Re: West Ridge Mine C/007/041  
Permit Change to Include Catchment Structures C and E  
Response to Violation #10063

Title: Response to NOV #10063 Items I and II, Coal Fines Catchment Structures

**ADDENDUM TO ADDRESS SECOND  
VIOLATION  
(ITEMS I and II)**

**VIOLATION #10063  
ISSUED JULY 21, 2010**

DRAWN BY	PJ	SCALE	NONE
APPROVED BY	DH	DATE	10 AUGUST 2010
SHEET			EXHIBIT 3

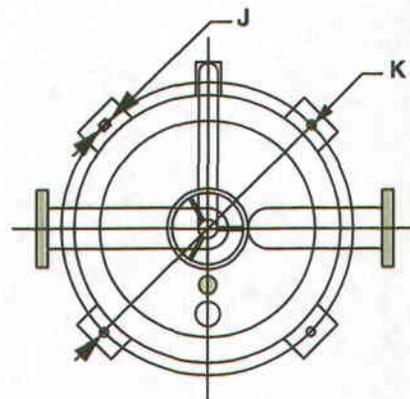
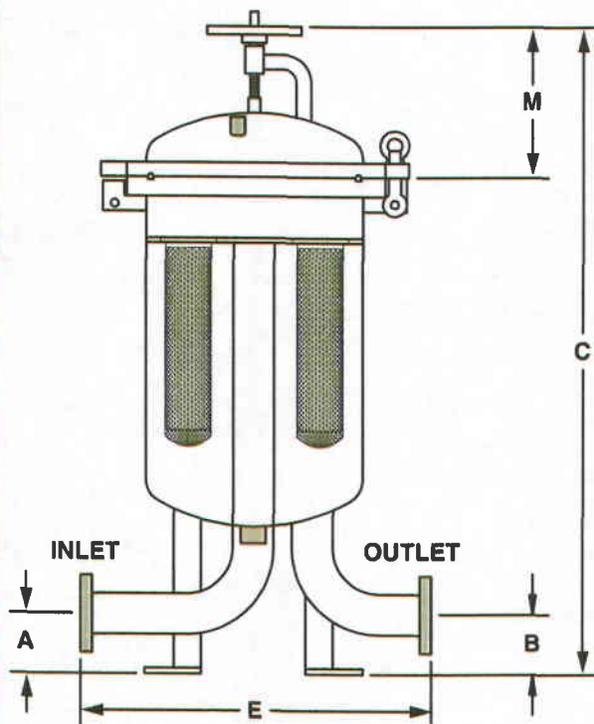
All mine-water discharge pipes will join together at the surface before being filtered. All mine-water will then be routed to the Schroeder BH10 Filtration System (Exhibit 3). This system is designed to filter up to 2000 gpm of discharge water. A bypass pipe will be installed to provide for filter changes and cleaning. Filters will be changed out on a regular basis.
